January 18, 2019

To: Matthew Donahue - SDOT
From: Brett Commander - BDI
CC: Jamie O'Day - SDOT, Kyle Ramer - BDI
Re:

As you are aware, in December 2018, BDI performed a brief inspection of the current monitoring system at the West Seattle High Bridge, including the interior and exterior portions of cracked box sections. The attached document provides a summary of observations, an assessment of the current condition, recommended actions by SDOT, and recommended options for continued monitoring.

Attachments: West Seattle High Bridge Monitoring Summary

Figure 1 Sensor wire field splices

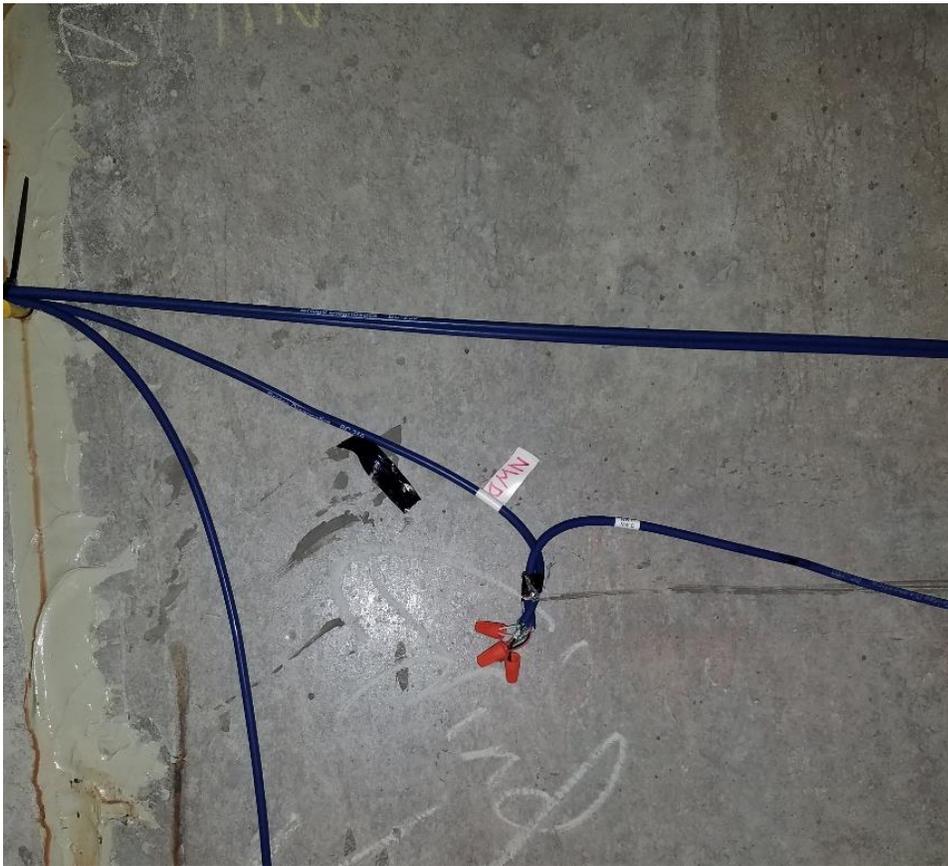
- Sensor wire field splices inside the boxes were of poor quality, consisting of twisted wires and wire nuts (Figure 1). These splices, although still functional, should be improved with crimped or soldered splice connections.
